Randwick Local Planning Panel (Electronic) Meeting

Thursday 13 March 2025

Development Application Report No. D10/25

Subject: 1605 Anzac Parade, La Perouse (DA/22/2025)

Figure 17: proposed plan for garage level at 1605 Anzac Parade (Source: Applicant)

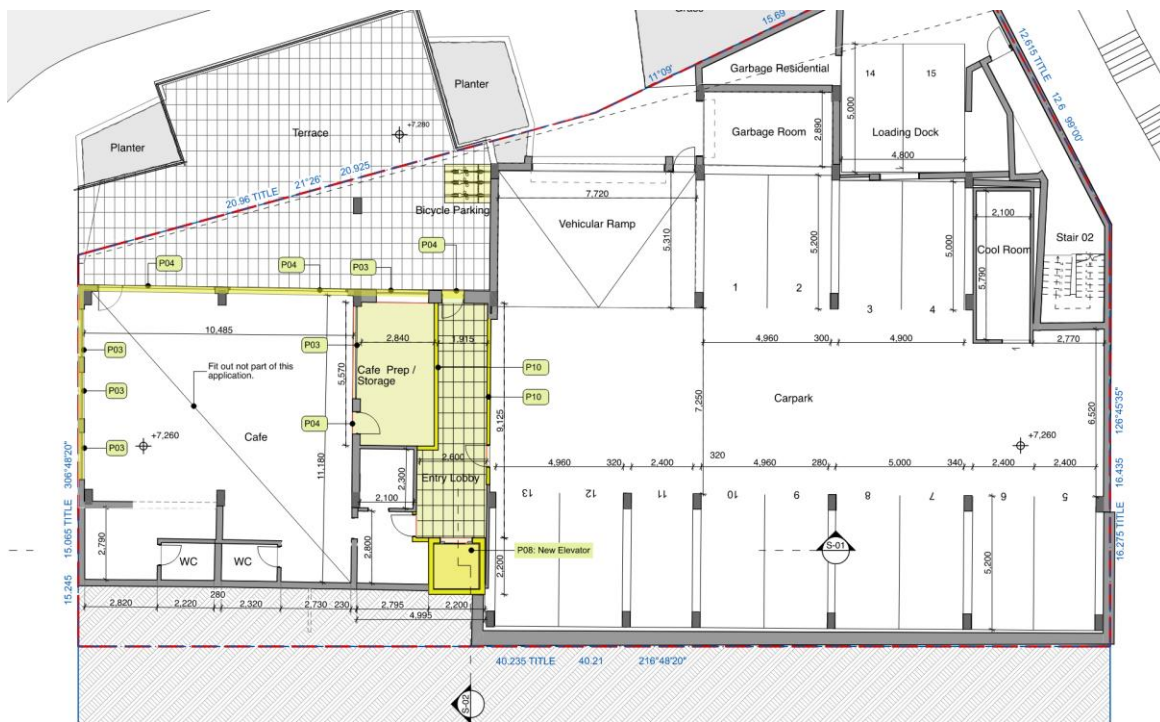
The approved plan of the parking is shown below (from October 2014). However, it appears there has been a slight rearrangement. The current (existing) plan (provided by the applicant) is shown below as well. From considering the report from DA/26/2002 it is understood that at that time 1 space was allocated to each of the three (3) two-bedroom units.

- The spaces being removed are difficult to access
- The proposed lift and entranceways are located in the most logical place to provide accessibility to the building.
- The proposal includes additional bike parking spaces.
- The addition of a café storage and prep area is being provided for without increasing the exterior footprint of the development.
- Technically, these existing car spaces are not compliant with the Australian Standard for width.
- A condition has been imposed for a Strata Parking Management Plan to be created.
- There is public parking available surrounding the development, in addition to frequent bus services.

Figure 19: First Floor Plan - detailing location of awnings and louvres (Source: Applicant)

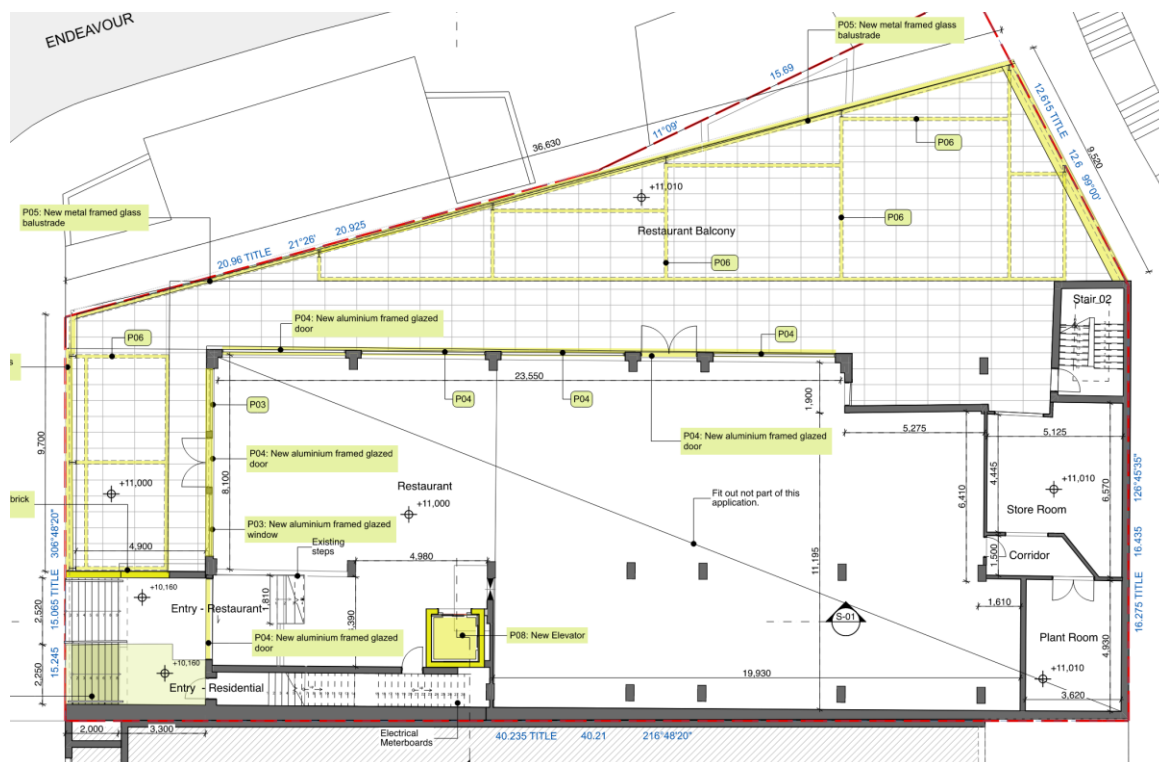
The replacement awning will increase the height of this awning to RL 14.0 (lower section) and RL14.9 for the upper section. These awnings will have a steel frame and external blinds, which retract along the perimeter of the buildings. The height along the perimeter is only being increased by 140mm.

Located behind the perimeter is the higher steel framed awning, which will include aluminium framed motorised louvres.

Figure 22: Proposed location of awning which must be setback

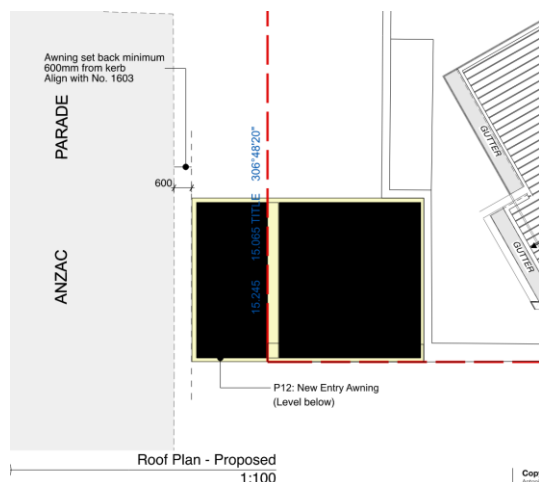
The replacement entrance awning will sit at the same level as the existing awning but will be flat instead of angled. A condition has been included that this awning must be setback to the property boundary and that no approval is granted for this awning to extend over Council's footpath.

The applicant can apply for a local approval Under the Local Government Act 1993 and Roads Act 1993 to construct an awning over the Council footpath should they decide to undertake these works.

Figure 15: Longitudinal Section

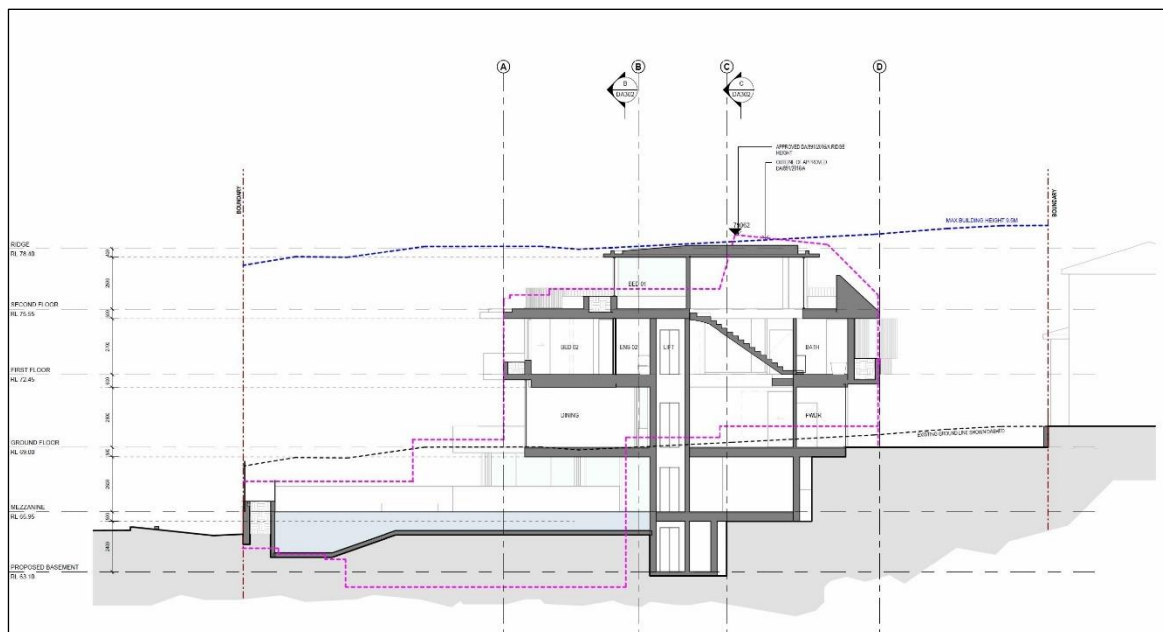
- The internal garage carspaces must be provided at a grade of between 0 and 5% to achieve compliance with AS 2890.1. The submitted long-sections (sheets 401 & 402) indicate the grade of the rear 2.6m of the carspaces will exceed this requirement thereby creating a non-compliance with the Australian Standard. The plans/sections are to be amended so that a minimum 5.4m length of garage floor slab is provided with grades of between 0 & 5%.
- An analysis of the driveway design using the B-85 design template in AS 2890.1 indicate vehicles may scrape at the southern edge of the footpath adjacent to the kerb on sections A-A and C-C. The Applicant will likely need to flatten the crossing at these locations.
- The above requirements may likely require the garage floor to be raised. Note the minimum head clearance required by AS 2890.1 is 2.20m. A 2.3m clearance is indicated on the sections

Figure 22: Extract of Elevation 1 plan prepared by Smyth & Smyth.

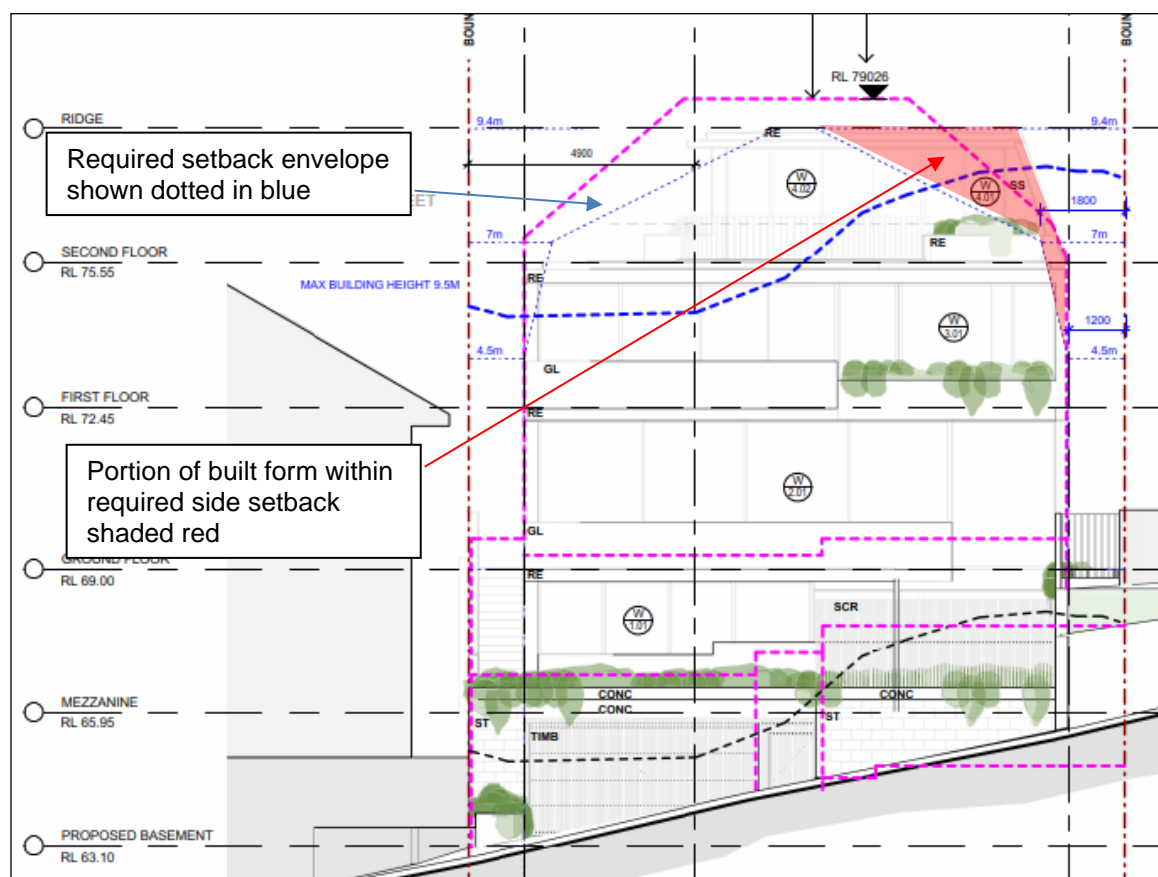
The mezzanine and ground floor levels comply with the abovementioned side setbacks. However, the top portion of the first floor and the majority of the second floor are within the required setbacks. The portion of the site between 4.5m – 7m in height is only setback 1.2m from the western side boundary while the portion of the building above 7m is only setback 1.8m from the western side boundary. This breach can be seen in the elevation plan prepared by Smyth & Smyth (refer to Figure 22 below).

The proposed breach to the side setback control is largely attributed to the proposal exceeding the storey height limit envisaged for low density residential development under Part C1, Section 3.2 of the RDCP 2013. The non-compliance with the minimum side setback control, along with variations to the RLEP 2012 building height and FSR standards, demonstrate that the proposal is an overdevelopment of the subject site, resulting in unacceptable amenity impacts to the streetscape and neighbouring properties.

Figure 23: Extract of shadow diagrams – June 21 8am prepared by Smyth & Smyth.

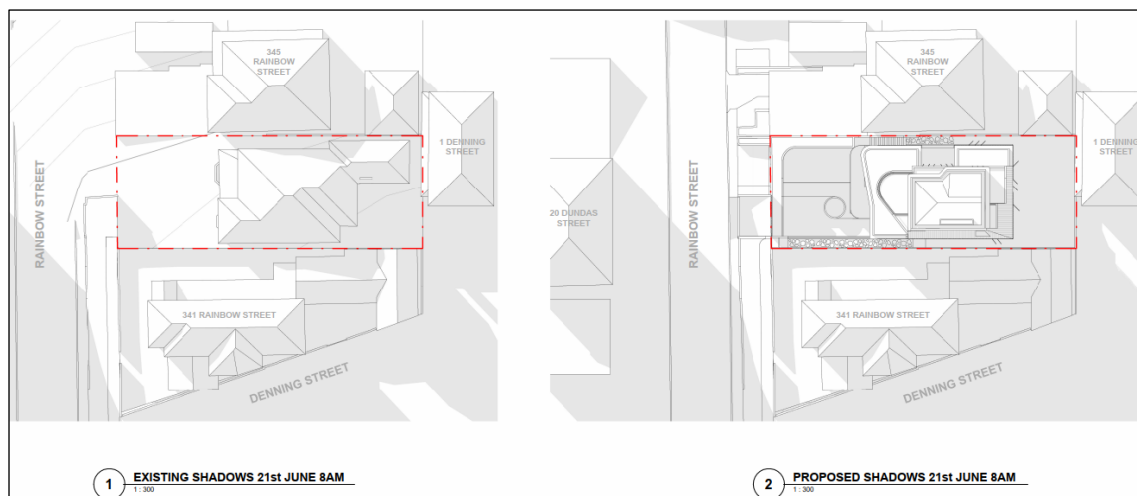
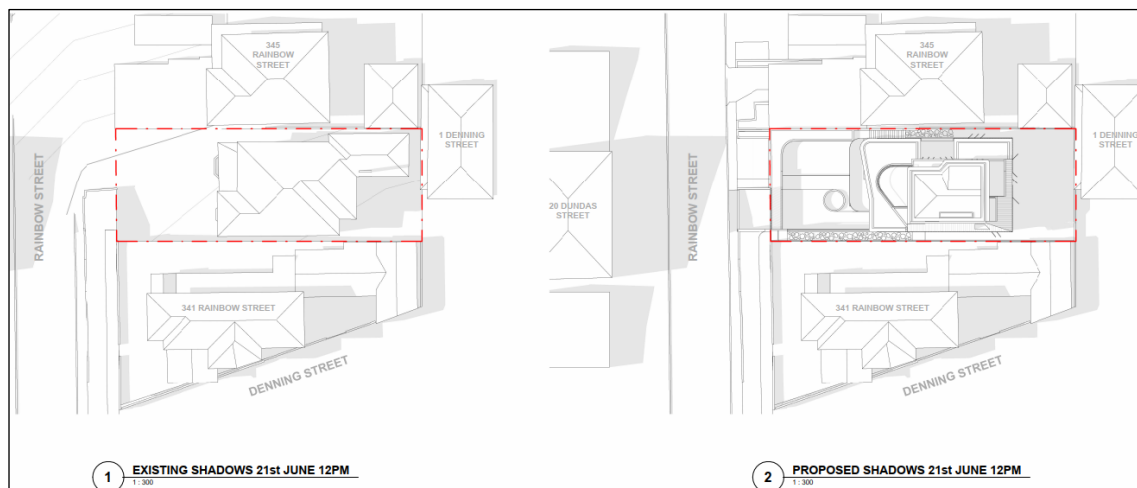
With regard to overshadowing of neighbouring properties, the shadow diagrams submitted with the application lack detail to conclusively determine if adjoining properties achieve the minimum amount

of direct solar access during the winter solstice. The shadow diagrams prepared have been provided for 8am, 12pm and 4pm only. At no stage does it appear that either adjoining properties at Nos. 341 or 345 Rainbow Street achieve at least 3 hours of sunlight to private open space areas as can be seen in Figures 14 – 16 below.
